**CERTIFICATE OF APPROPRIATENESS**

**Property:** 528 Highland Street, Lot 8 & Tract 7, Block 20, Woodland Heights Subdivision. The property includes a historic one-story residence situated on a 7,500 square foot (75' x 100') corner lot.

**Proposal:** Alteration – Request for HAHC approval of completed and partially completed alterations that have exceeded the scope of work approved in two previous COAs.

**Recommendation:** Denial - does not satisfy criteria

### EAST SIDE ELEVATION

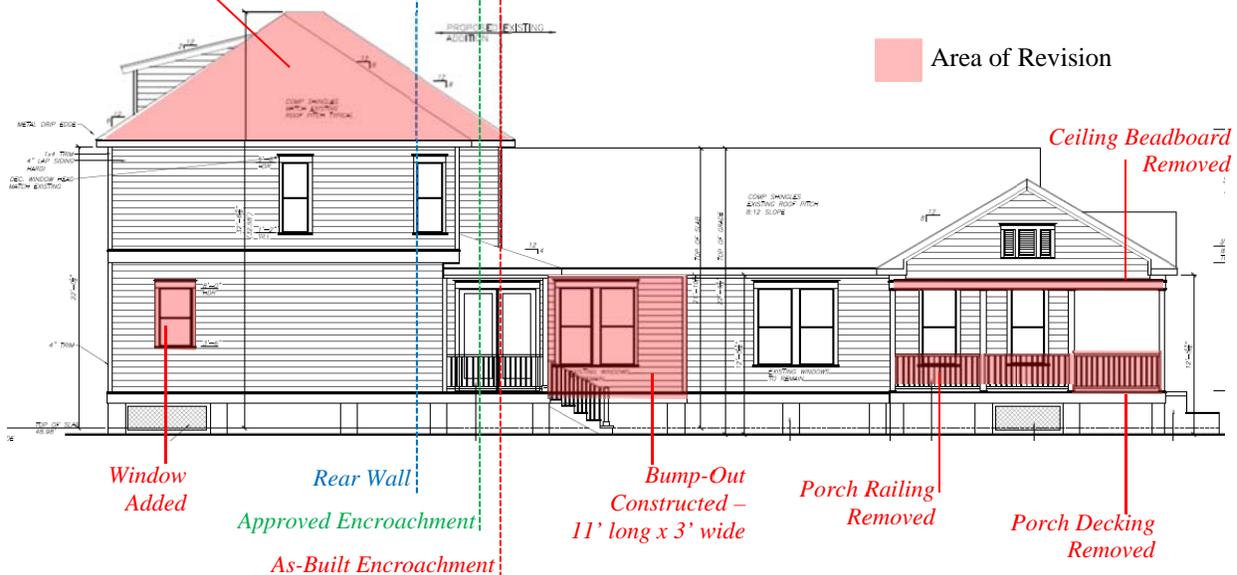
*Roof Pitch Altered and Ridge Height increased by 2'*

**SOUTH (REAR) ELEVATION**  
**EXISTING**

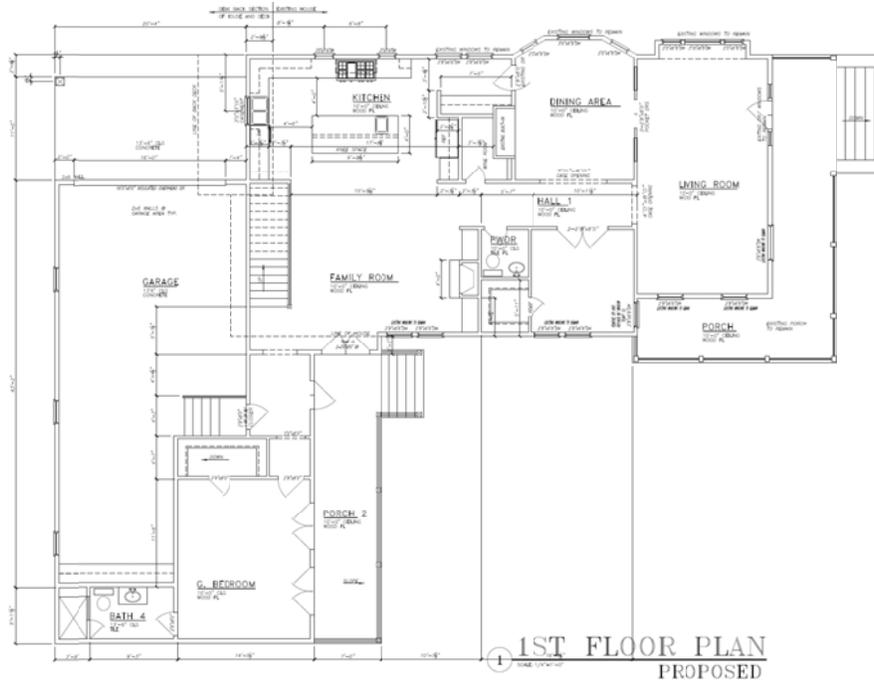
Area of Revision

FIRST FLOOR PLAN  
APPROVED FEBRUARY 2014

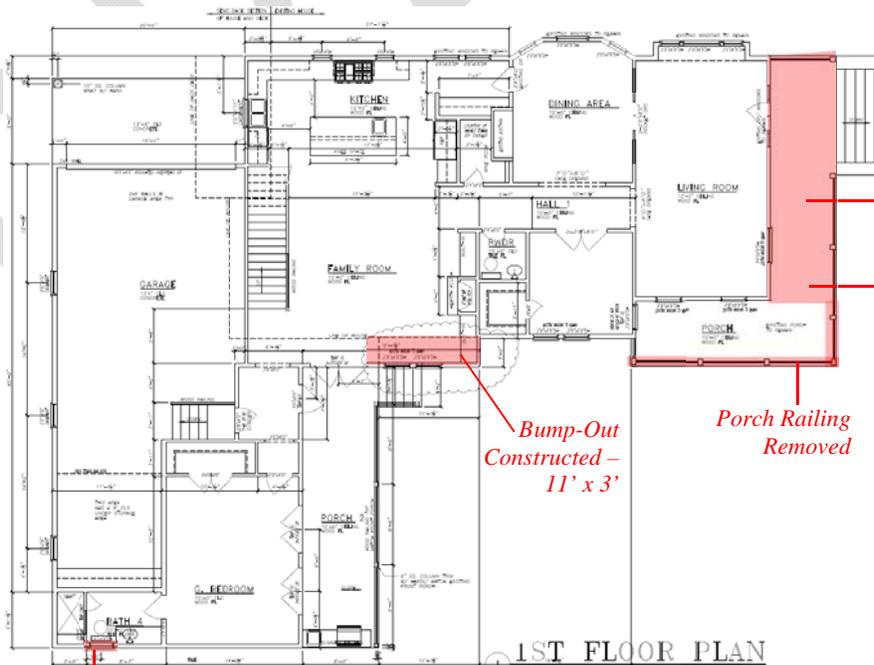
Porch Decking  
Removed

Beadboard  
Ceiling  
Removed

Porch Railing  
Removed

Bump-Out  
Constructed -  
11' x 3'

Window  
Added

**SECOND FLOOR PLAN**

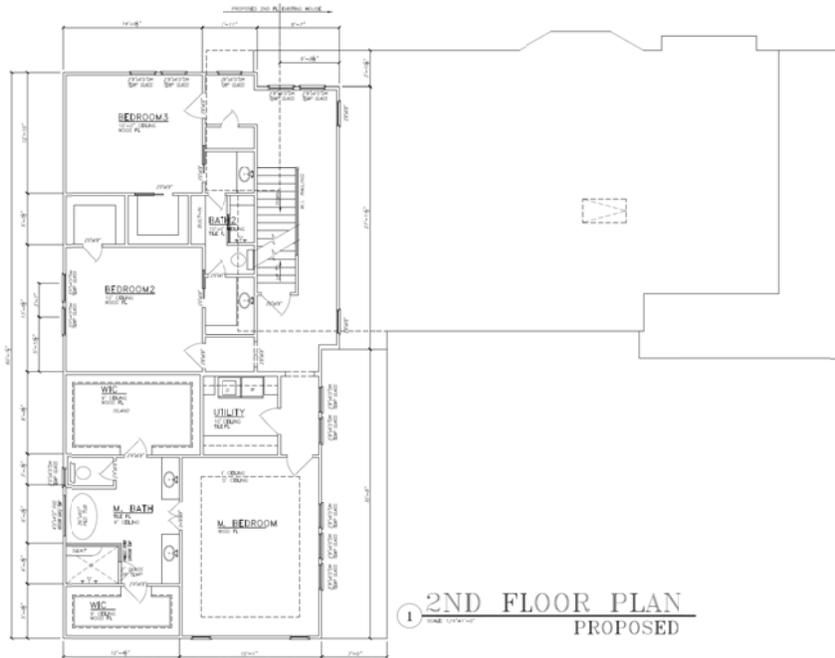
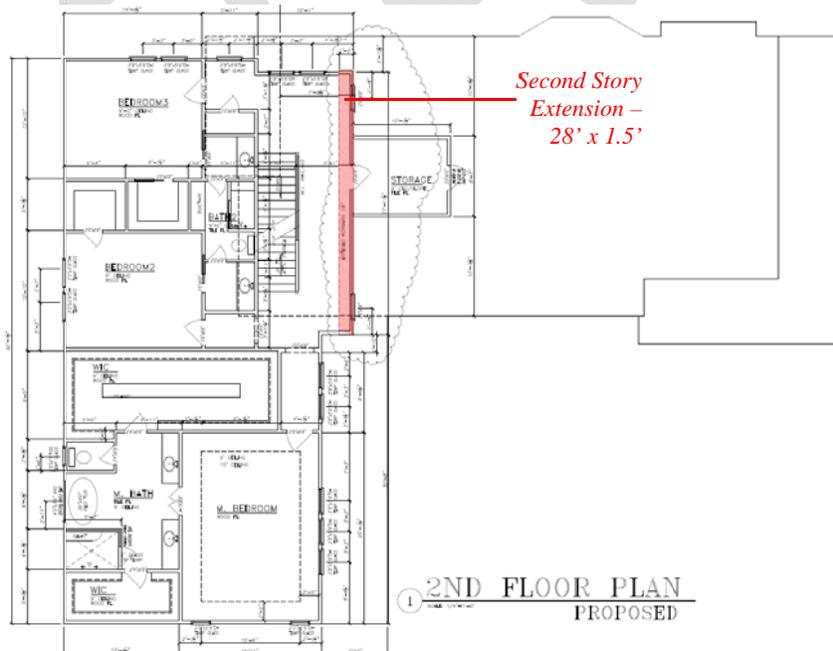
- The second story addition extends 18" farther onto the original house than approved. This encroachment runs for 28' along the front elevation. No explanation of why this happened has been provided.

### ROOF PLAN

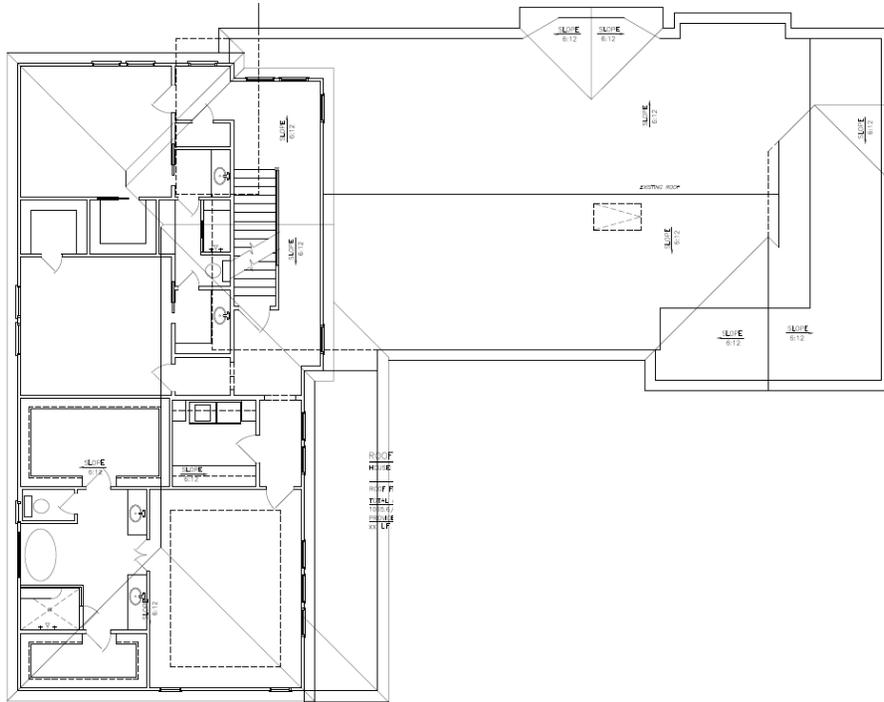
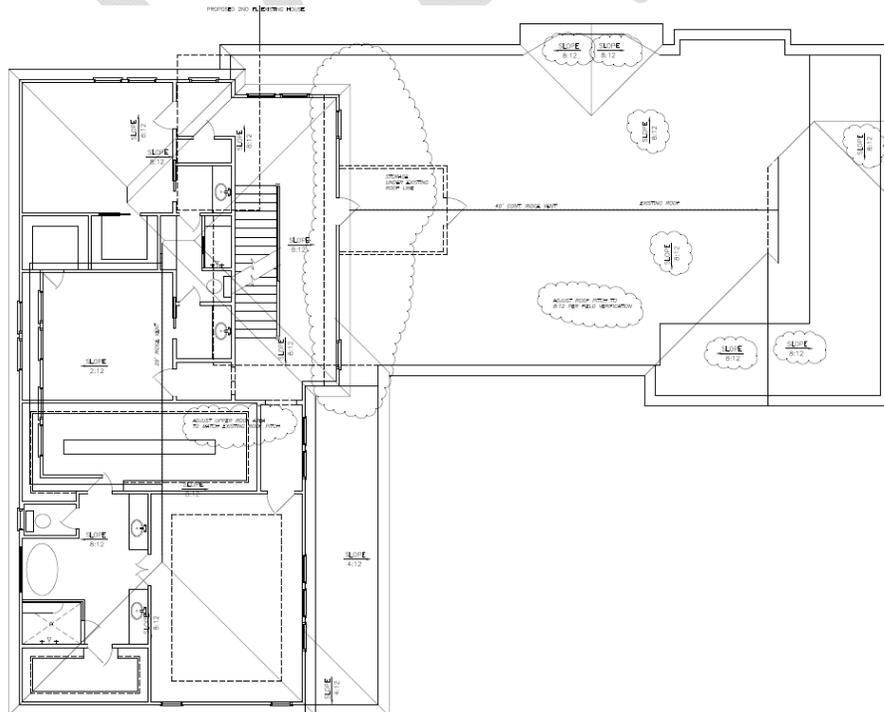
- Constructed a front gable roof as opposed to a hipped roof. Inconsistencies were discovered with the approved stamped set of plans. Plans showed a hipped roof on all elevations and a gable roof on the roof plan.

- Incorrect roof pitches. Plans note that existing roof pitch is 6:12 and that the proposed addition roof was to match existing at 6:12. However, the applicant's designer "eyeballed" the existing roof pitch and was incorrect with 6:12. The existing roof pitch is actually 8:12 and therefore, the roof of the addition was built at 8:12 (to match existing) and not at 6:12. If staff was aware of the existing 8:12 roof pitch, staff would have advised that applicant to reduce the roof pitch to 6:12, or lower, in order to reduce the height of the structure.
